March 17, 2021
DAT-2021-009

Subject: Response to Ecology's February 1, 2021 Comments on the Draft Feasibility Study and Draft Supplemental Feasibility Study Reports
Boeing Auburn Facility
Agreed Order No. 01HWTRNR-3345

Attachment A – Application of Appropriate Cleanup Levels

Attachment B – Response to General Comments

FIGURE A-1

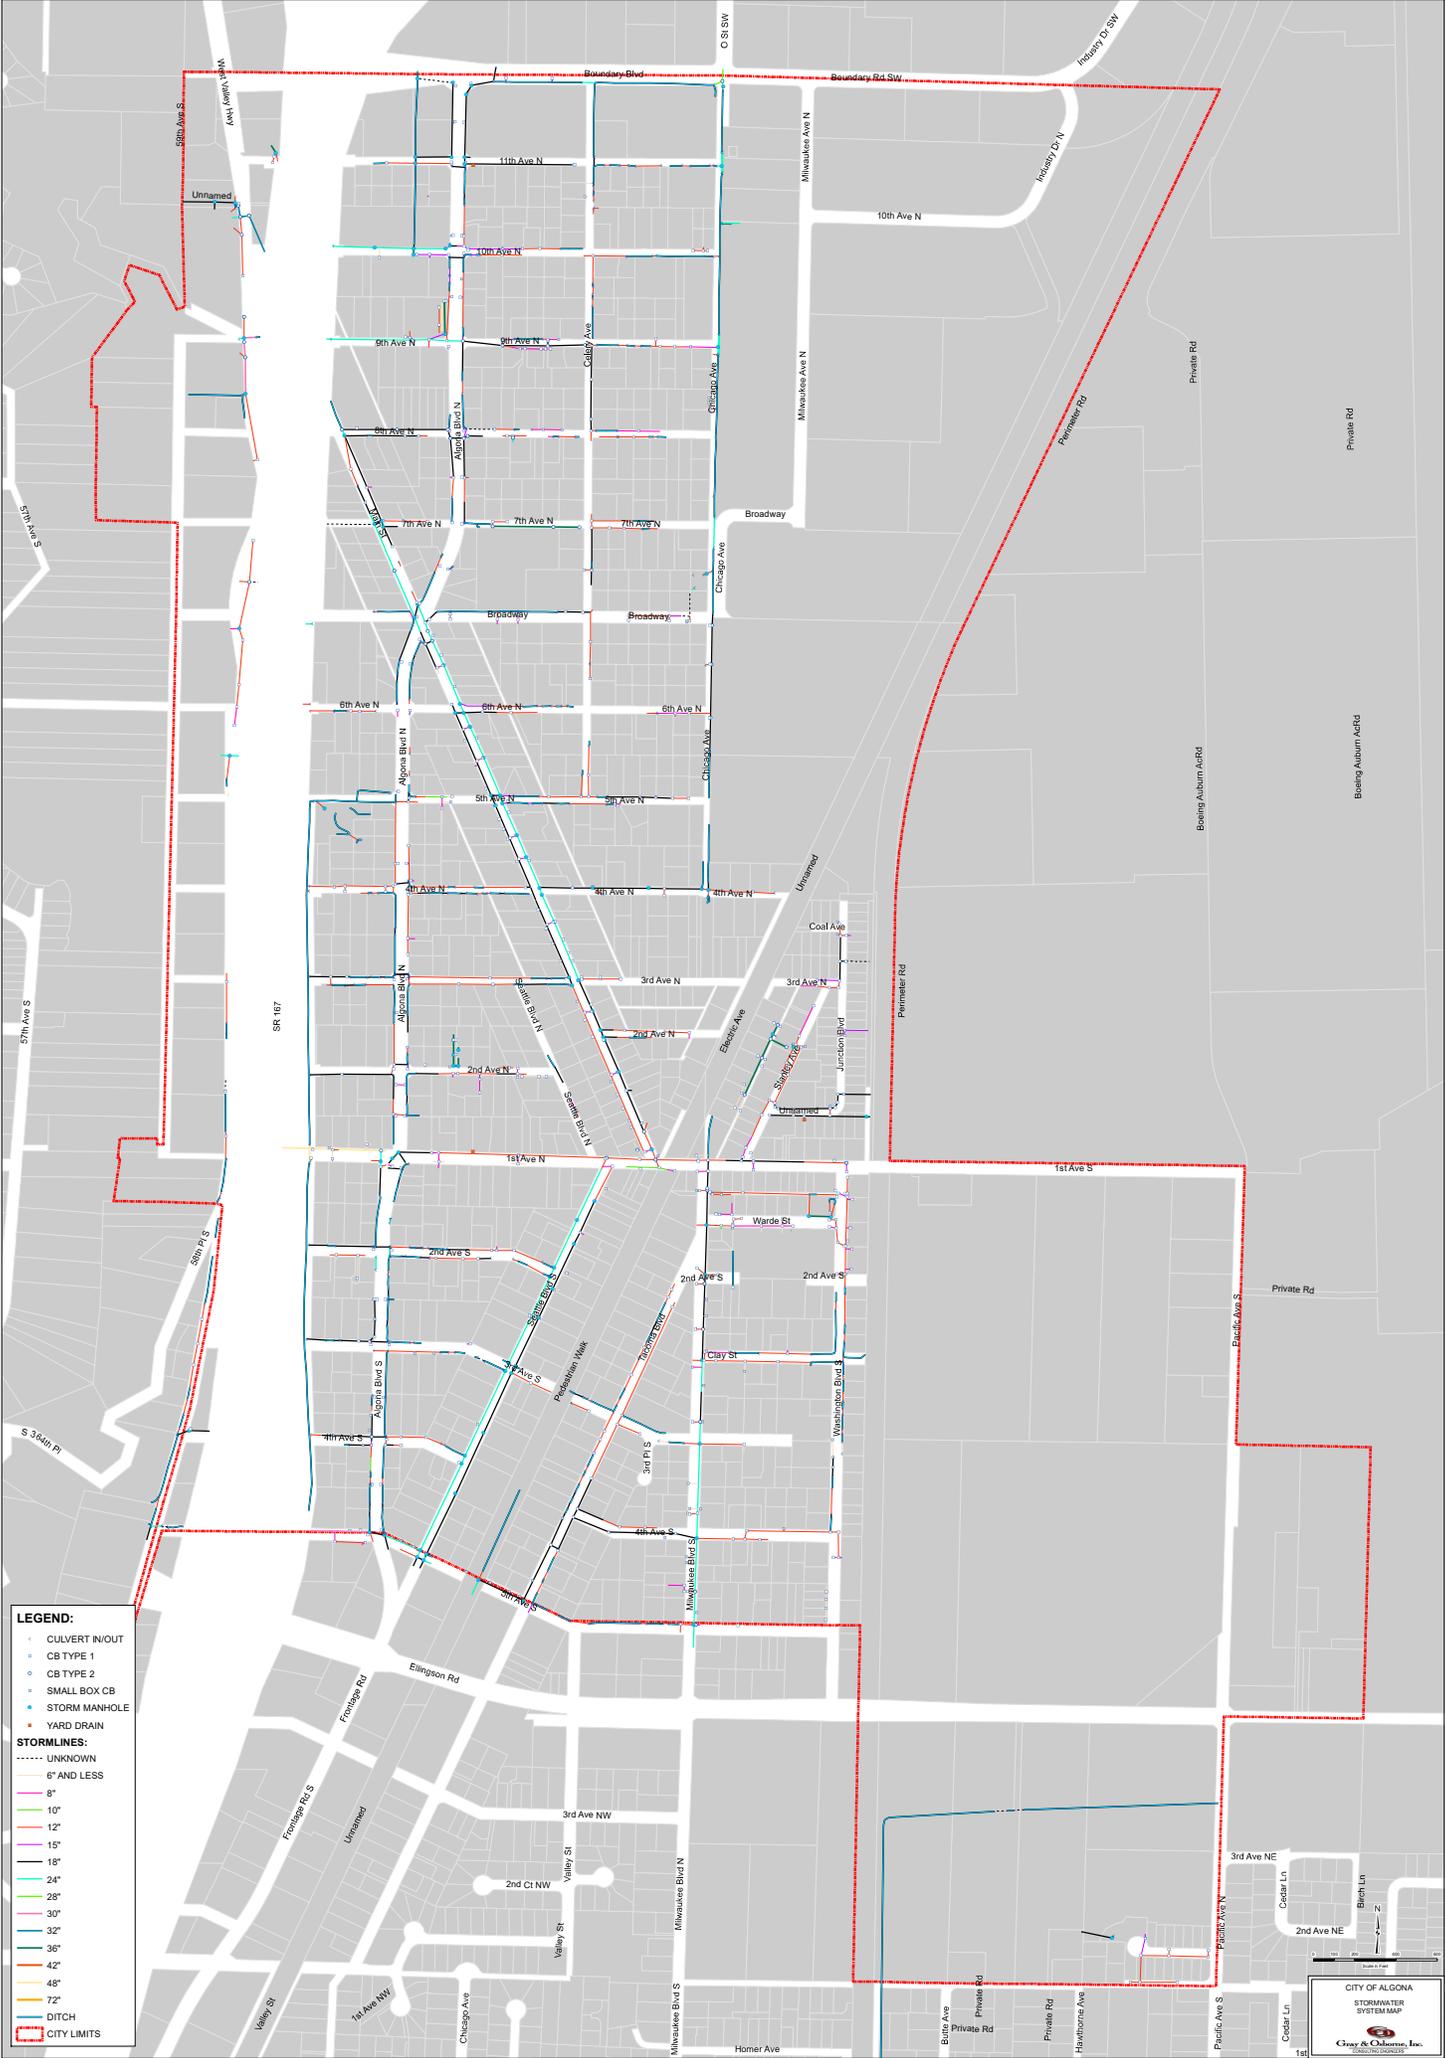
Boeing disagrees with Ecology's comments asserting that SWQS apply to the Chicago Avenue ditch and the Auburn 400 basins. Ecology's rationale, as discussed below, is insufficient to support its conclusion that SWQS would apply to these stormwater features. Ecology has not provided sufficient rationale to refute Boeing's technical and legal discussion (Section 3.2.3 of the draft FS and Section 1.3.1 of the draft SFS) and legal position (Appendix B of the draft FS report). Boeing reiterates its previous statements on this issue and provides additional discussion below and supporting documentation for the main regulatory, policy and legal principles that demonstrate it is inappropriate to apply SWQS to these stormwater features.

SWQS criteria protective of drinking water and fish consumption are not applicable to stormwater conveyances, treatment, and control structures (including the Chicago Avenue ditch and the Auburn 400 north and south stormwater basins). Ecology's regulations support this conclusion. WAC 173-201A-260(3)(f) provides that human-created features used to remove and contain pollution are not subject to the numeric criteria for waters of the state. This regulation does not state that the features must have been intended for or created for that pollution removal/containment purpose, but only that the features serve that purpose. As some Ecology water quality staff have correctly concluded,³ clearly the basins, and the ditch that channels stormwater to the basins, serve that pollution removal/containment purpose. It is also clear from the City of Algona's stormwater base map that the Chicago Avenue ditch is a stormwater conveyance feature (a "stormline" on the map, see Figure A-1, attached). The Chicago Avenue ditch and the Auburn 400 basins are defined, per Ecology guidance, as stormwater features.⁴ Construction plans for the Auburn 400 basins identify these specifically as "sediment collection basins" (see Figure A-2, attached).

Ecology's rationale, that this is "all one interconnected surface water system," is not accurate or pertinent to the decision of whether SWQS apply to these features. The available evidence, and the function of the features, show they serve the purpose of removal/containment of stormwater and are not simply to convey water, as discussed in WAC 173-201A-260(3)(f)(ii). The basins are not designed for conveyance; they receive and settle stormwater, which is a classic stormwater treatment practice to remove and contain pollutants in stormwater. Also, the ditch was designated by the local government as a stormwater feature.

In addition to Ecology's water quality regulation demonstrating that these are stormwater features to which SWQS do not apply, the MTCA regulation also supports the conclusion that SWQS should not apply to these stormwater features. WAC 173-340-730(1)(c) provides that "the department does not expect that cleanup standards will be applied to stormwater runoff that is in the process of being conveyed to a treatment system." While these regulations make clear that SWQS do not apply to these stormwater features, Boeing understands that the waters must be managed to meet subsections (i)(A) and (B) of WAC 173-201A-206(3)(f) and Boeing commits to doing so. Boeing will

continue to monitor the Chicago Avenue ditch and the Auburn 400 basins to ensure that concentrations do not exceed health standards set by the Washington State Department of Health so that subpart A is met. In addition, Boeing will also continue to monitor locations in Mill Creek to ensure that discharges from these systems meet downgradient surface water quality standards to ensure compliance with subpart B.

FIGURE B-1

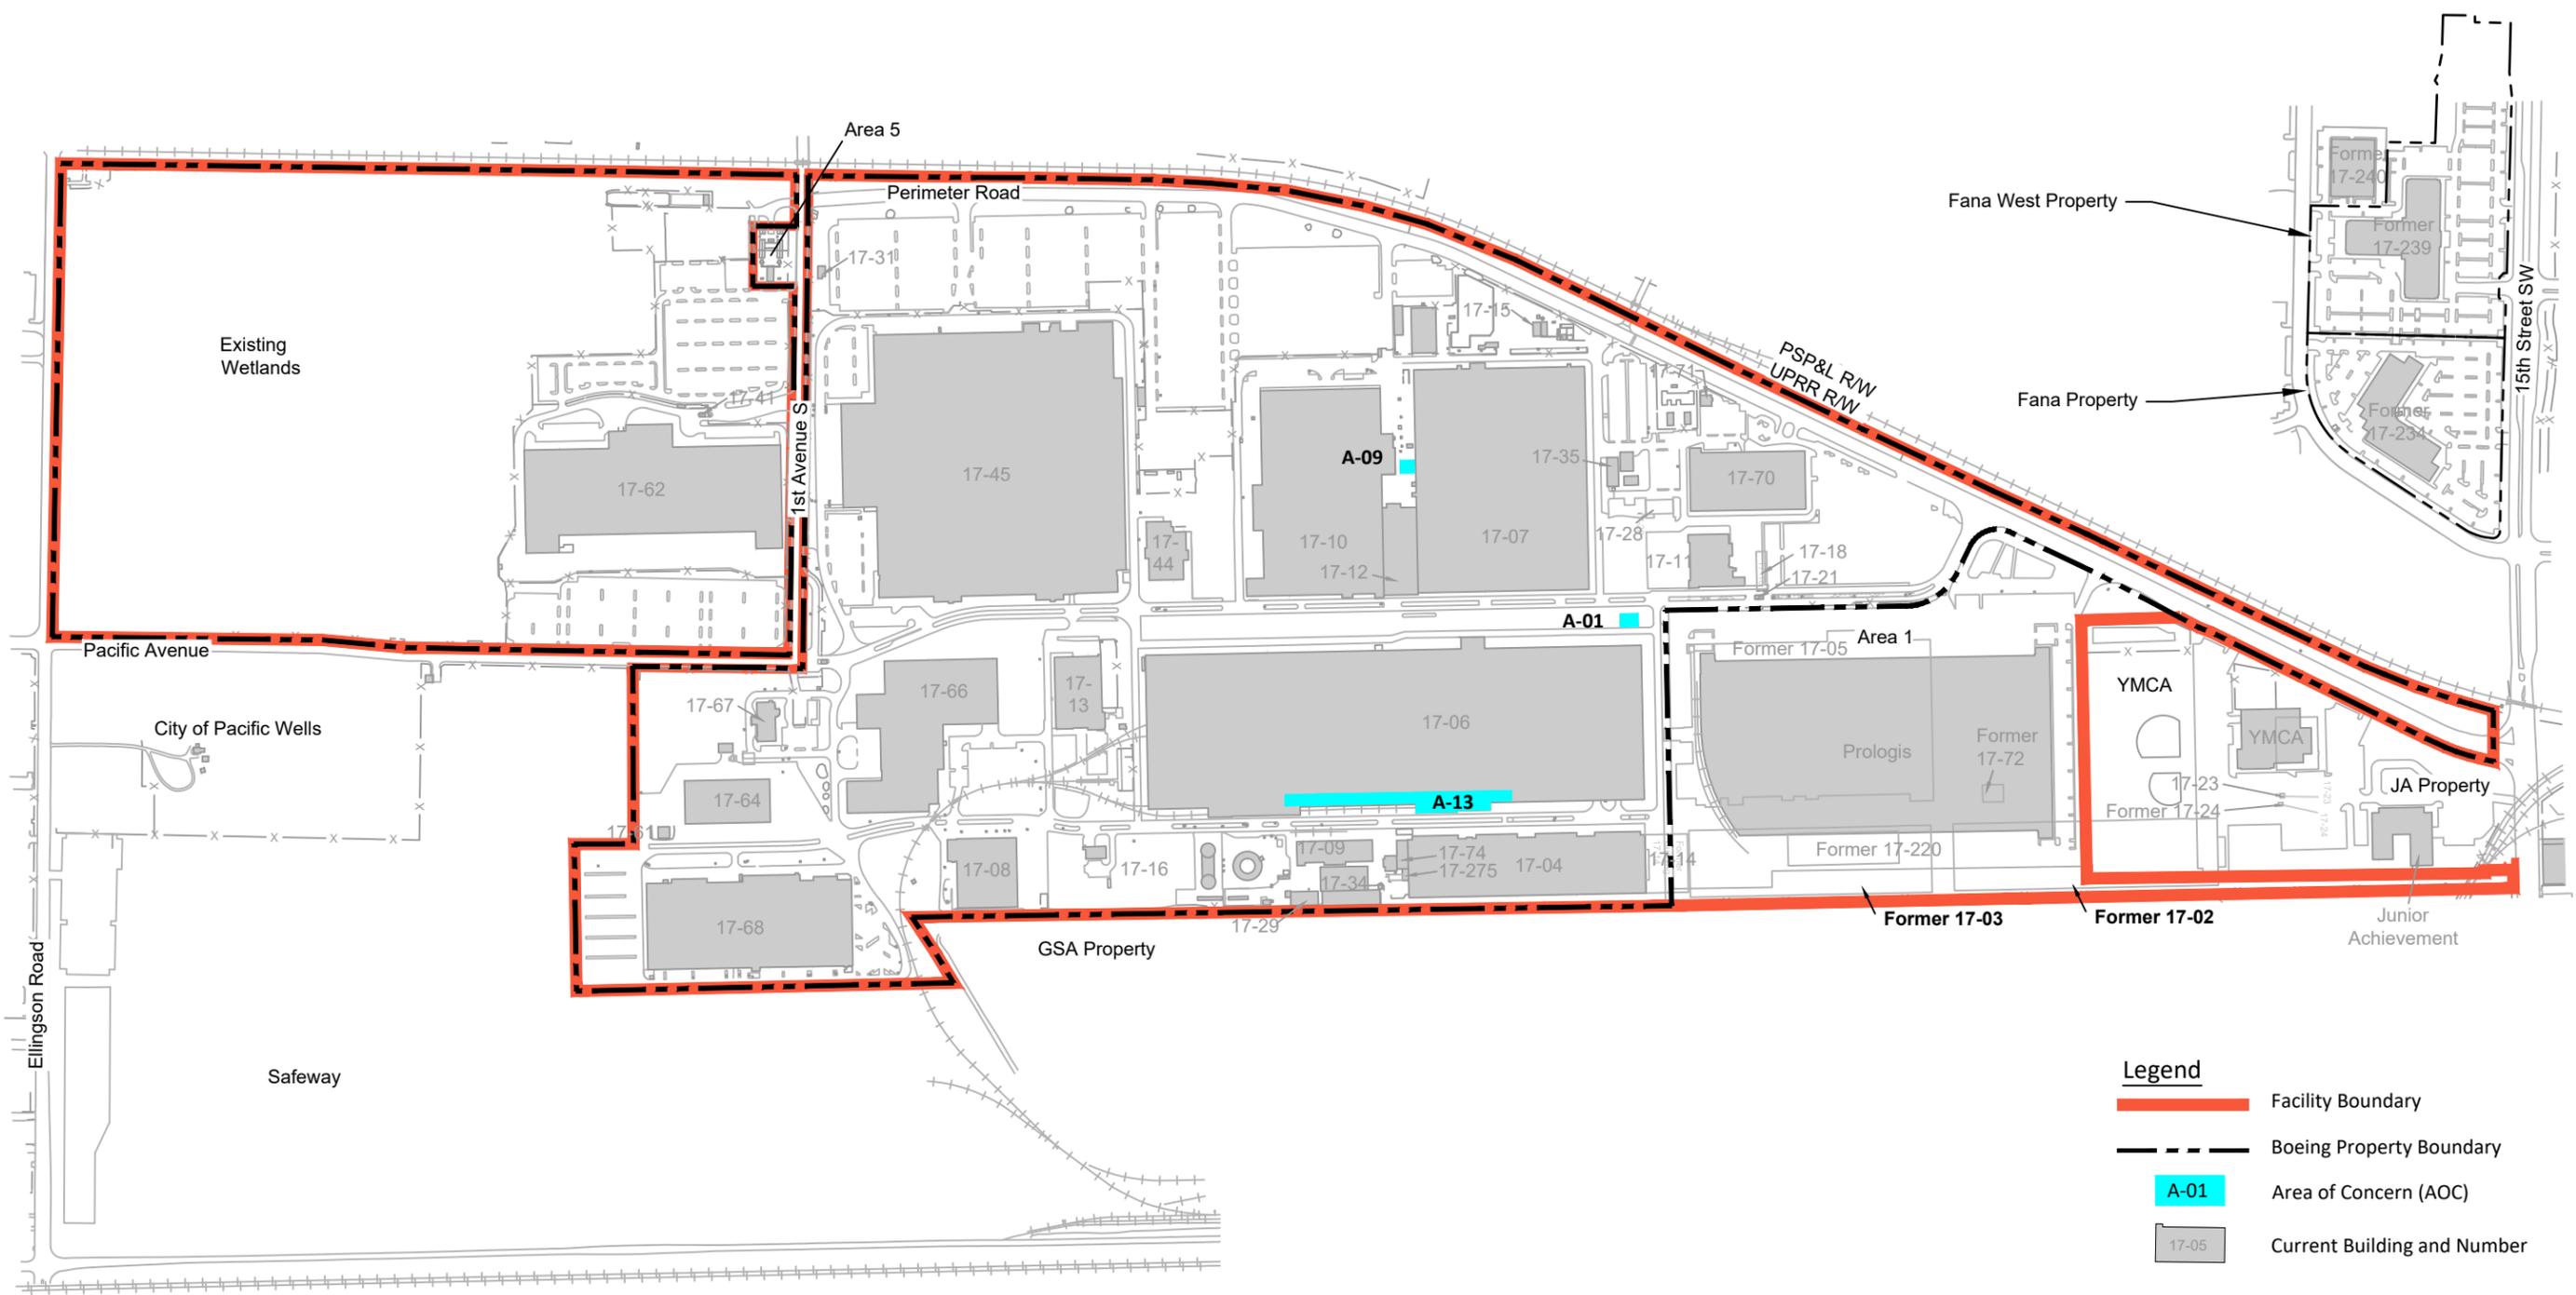
In addition, in informal comments, Ecology asked for clarification on the areas where environmental covenants and institutional controls will be applied for the Boeing Auburn Facility (Facility) areas of concern ([AOCs]; AOC A-01, AOC A-09, and AOC A-13). A general outline of the AOCs (as shown in the FS) is attached (See Figure B-1). Boeing will modify this figure and propose areas for implementation of institutional controls and/or environmental covenants for specific soil areas associated with AOCs on property owned by Boeing as part of the dCAP.¹ If implementation of environmental covenants is proposed on other portions of the Facility not owned by Boeing, they will be contingent on approval from the property owners. Ecology will be responsible for enforcing the implementation of environmental controls and institutional controls on property owned by other potentially liable parties to the Agreed Order (AO).
